Retreat at TimberRidge

PRELIMINARY PLAN

EL PASO COUNTY, COLORADO

SP 182

| PRELIMINARY GRADING PLAN | | | |

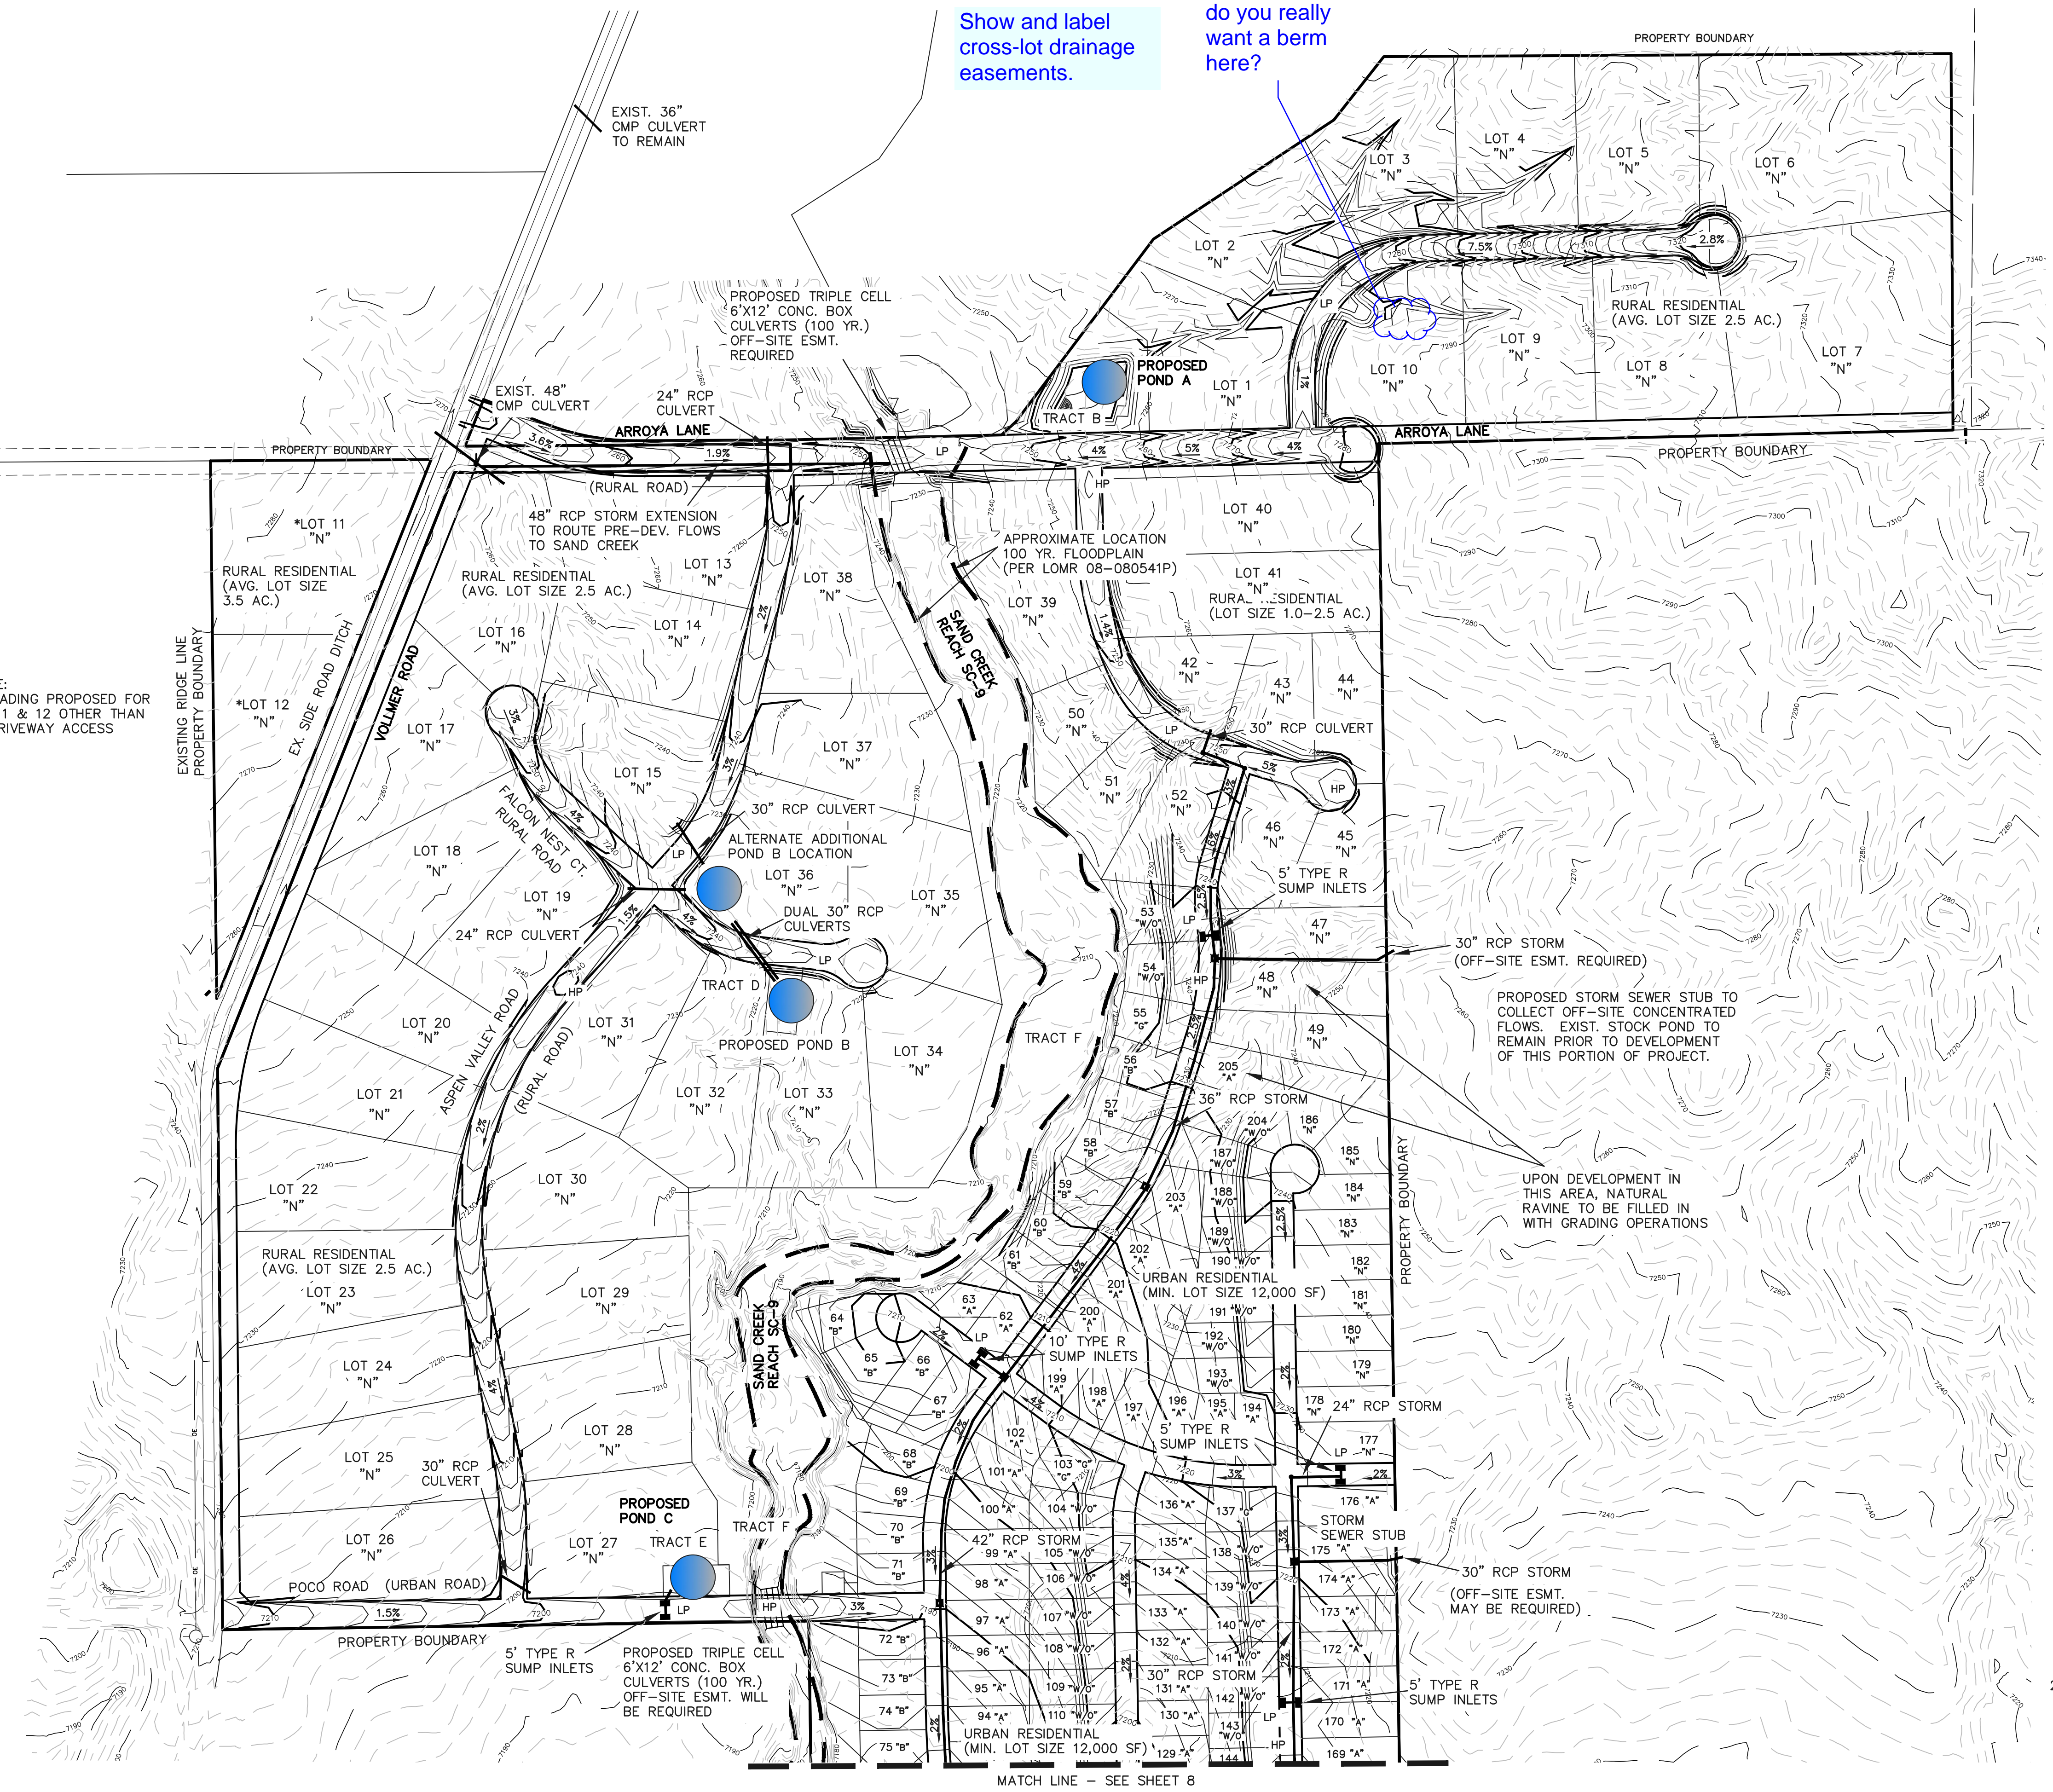
Show and label cross-lot drainage easements.
do you really want a berm here?
